Architectural Review Board Staff Report

Meeting Date: March 10, 2016

Description: Trails West Village of Greentrails, Lot 270 B: A Site Development Section Plan,

FRONT AND REAR 3D VIEWS

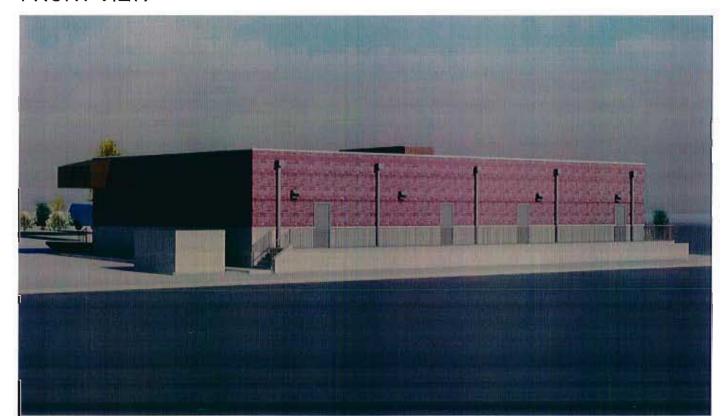
In the Architectural Elevations and rendering, the parapet is shown as being extended around the building. However, the Architect's Statement of Design states "there will be no parapet on the rear of the building." The inclusion of a parapet wall on the rear façade as shown in the elevations would provide consistency to the design on all sides while also providing screening to the lower portion of the roof top mechanical units.

A glass storefront is proposed, with the bottom panel called out as "bronze insulated panel" on the Architectural Elevations. However, the call-out is visibly inconsistent with the actual elevations and rendering, which clearly show a glass panel. Staff does not have a concern with these panels being either glass or a bronze insulated panel considering both materials/colors are used elsewhere on the building; however, the inconsistency must be addressed prior to Planning Commission.

The applicant is proposing a screen unit for the roof-mounted mechanical equipment. Although this screen unit is shown as being constructed of wood on both the Architectural Elevations and rendering, the checklist included in the submittal packets indicates that the screen "will use the standing steel material instead of wood." This information was not presented to Staff prior to receipt of the meeting packet and depending on the design could be a concern.

Due to the residential nature of the surrounding development, Staff requested that a sight-line study be provided related to the proposed mechanical screening; however, the applicant has elected not to provide this document. The roof-top screening, including the apparent change in material, remains under review by Staff and input on this item from the Architectural Review Board is encouraged.
